PERMIT # 215430

SEPTIC IMPROVEMENT PERMIT / AUTHORIZATION TO CONSTRUCT / OPERATION PERMIT / EXISTING SYSTEM

SITE ADDRESS: 118 Tuscany Trail Mooresville, NC PHONE: 704 388-1994 ALT. PHONE Not Instal

SUBDIVISION: The Point ON NORMAN SECTION: 10 LOT # 1016 LOT AREA: .716 Ac DESIGN FLOW: 480gpd L.T.A.R.: .3 I / .4 Re

AS BUILT SKETCH

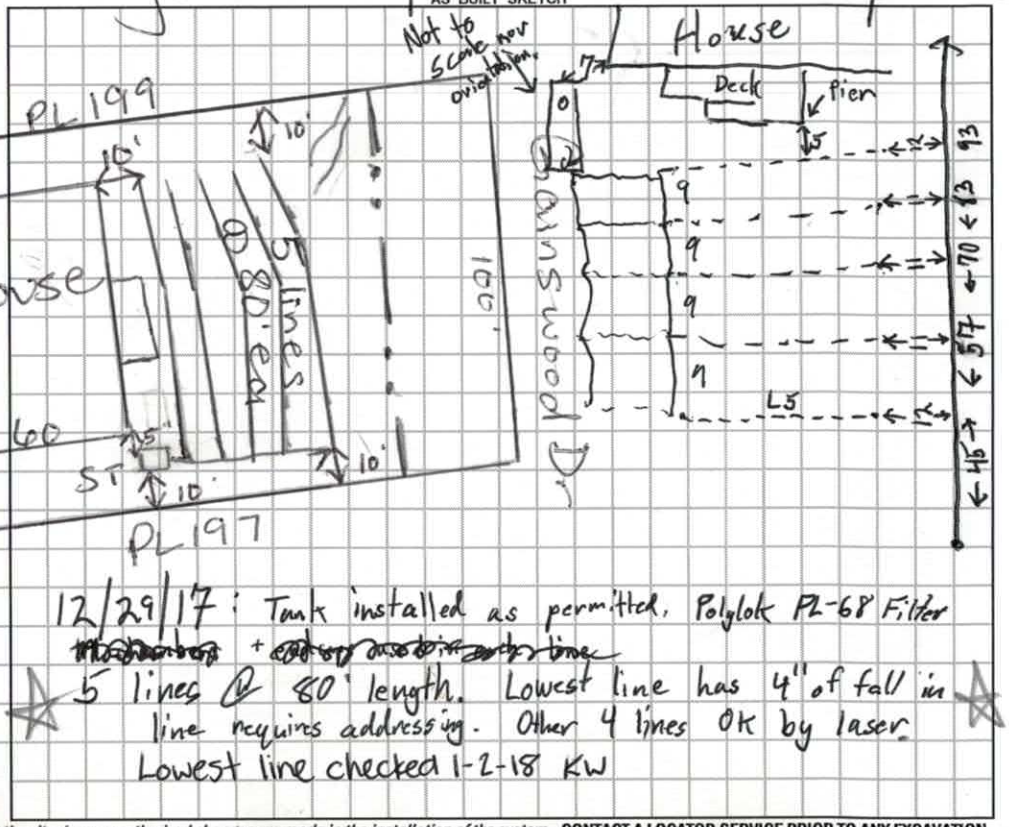
12/29/17: Tank installed as permitted, Polylok PL-68 Filter ~~Modernbond~~ + ~~add'l pipe in each line~~

5 lines @ 80' length. Lowest line has 4" of fall in line requires addressing. Other 4 lines OK by laser. Lowest line checked 1-2-18 KW

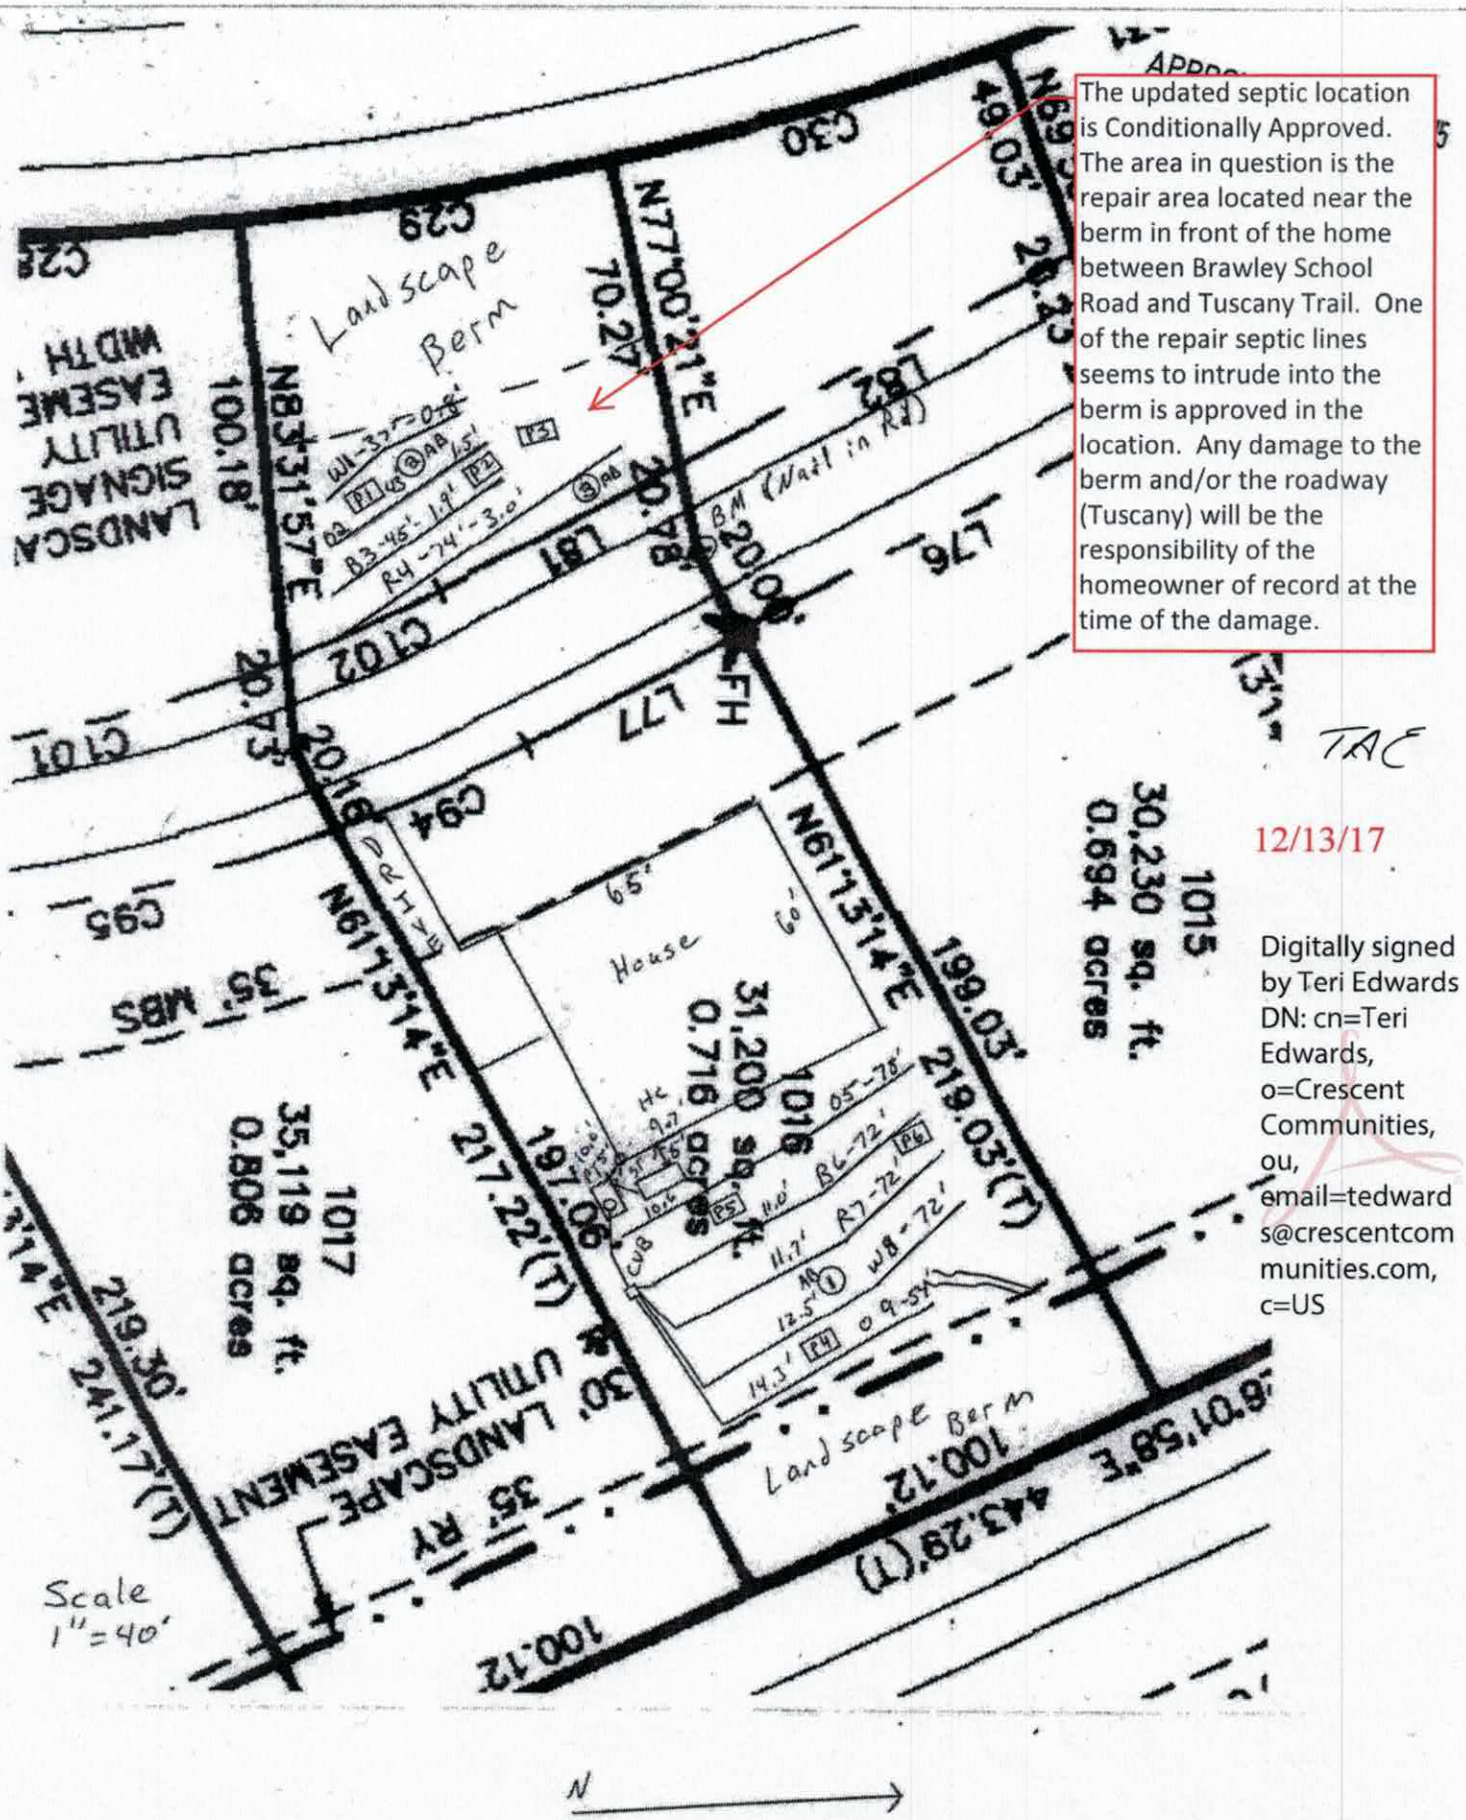
The updated septic location is Conditionally Approved. The area in question is the repair area located near the berm in front of the home between Brawley School Road and Tuscany Trail. One of the repair septic lines seems to intrude into the berm is approved in the location. Any damage to the berm and/or the roadway (Tuscany) will be the responsibility of the homeowner of record at the time of the damage.
Landscape Berm
House
65'
60'
31,200 sq. ft.
